AEMO 2019 Planning and Forecasting Consultation

AusNet Services welcomes the opportunity to make a submission to AEMO's 2019 Planning and Forecasting Consultation Paper.

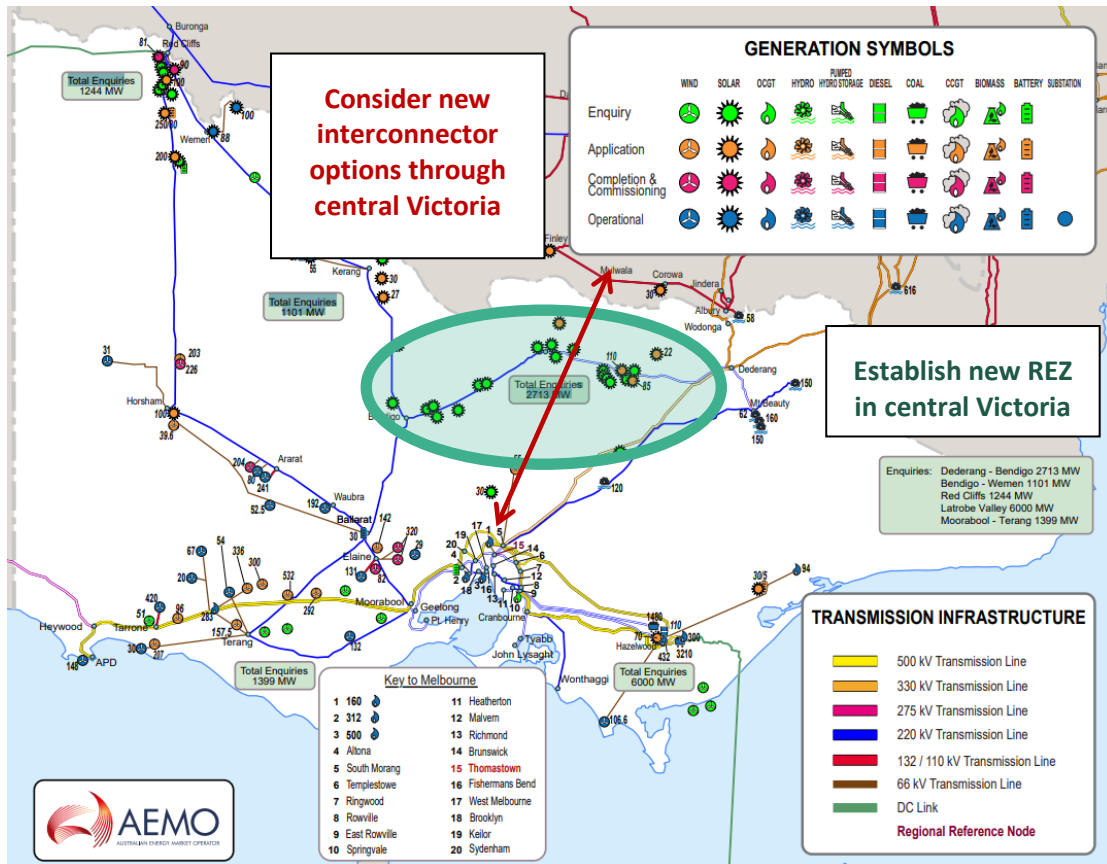
- The addition of a new REZ in Central Northern Victoria around the Glenrowan and Shepparton terminal stations (indicated by green oval). This area satisfies many of the REZ locational factors and has a high level of interest from renewables developers (2713 MW of current enquiries and applications according to AEMO latest information). This would also suggest alternative interconnector options from VIC to NSW through central Victoria and the new REZ.

4.5 Renewable Energy Zones

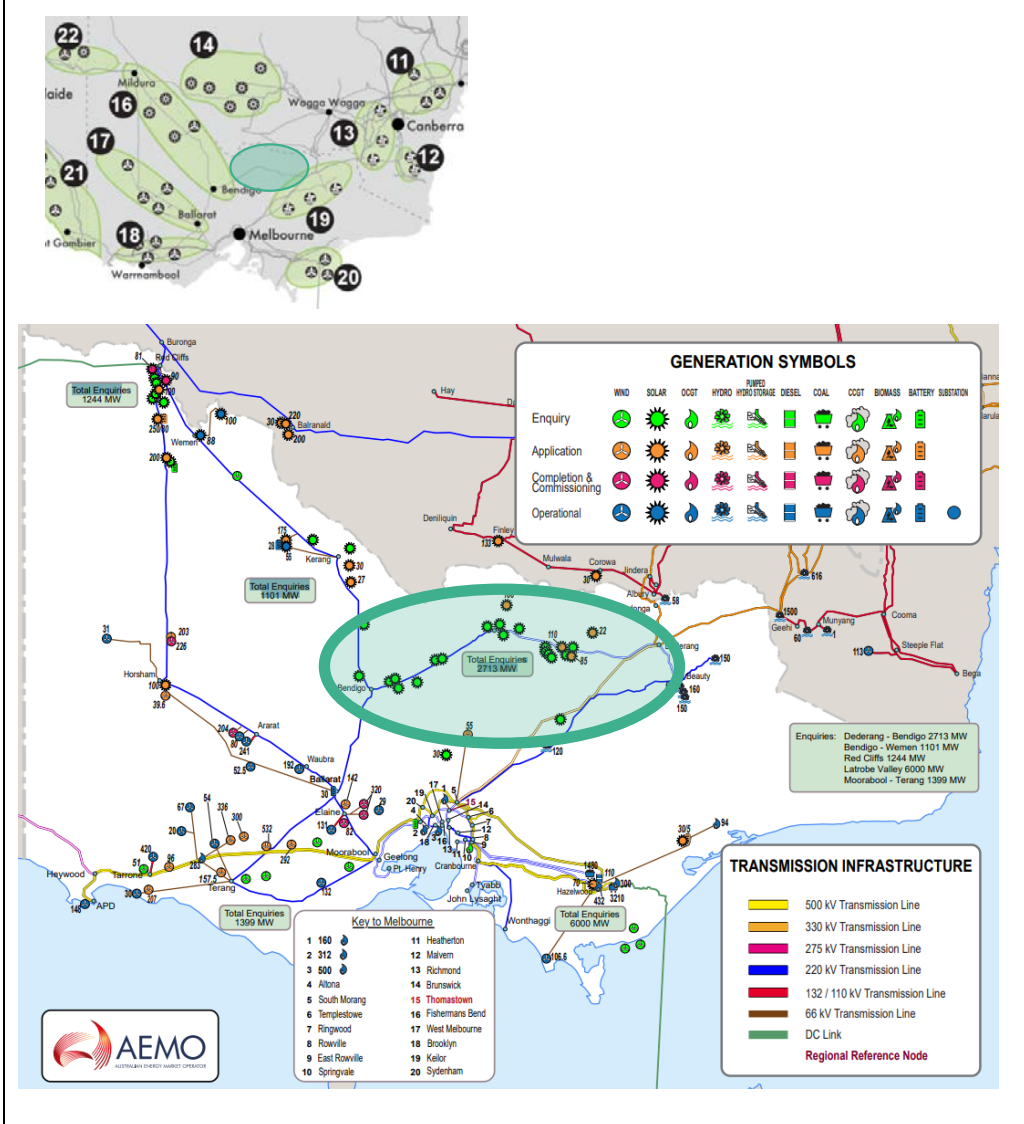
AusNet Services suggests an additional REZ in Victoria is warranted in central/north Victoria region around the Shepparton and Glenrowan Terminal Stations. This area has a large volume of interest from renewable developers and meets the following REZ criteria: good solar resource; and access to electrical network. This area benefits from reasonable existing network capacity, close ties to the existing VIC-NSW interconnector and potential to connect to a future 2nd VIC-NSW interconnector to increase capacity.

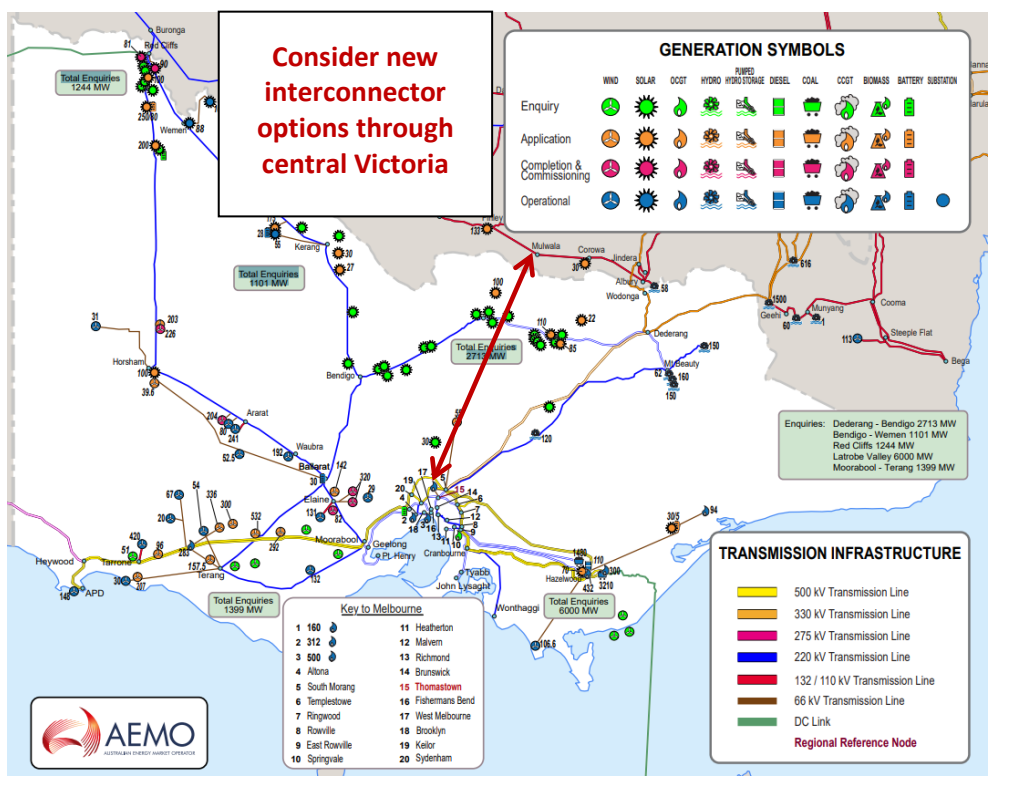
In conjunction with the identification of a new REZ in north central Victoria, AusNet Services suggests the next ISP should consider other credible options for interconnection from Victoria to New South Wales.

SnowyLink South was included in the 2018 ISP, however other credible options may provide greater benefits and should be considered in more detail now that both the EnergyConnect and Snowy 2.0 projects have a greater degree of

certainty. We suggest routes through central Victoria that are diverse from the existing VNI but provide a shorter electrical route from Melbourne to the Snowy 2.0 generation/storage and EnergyConnect.
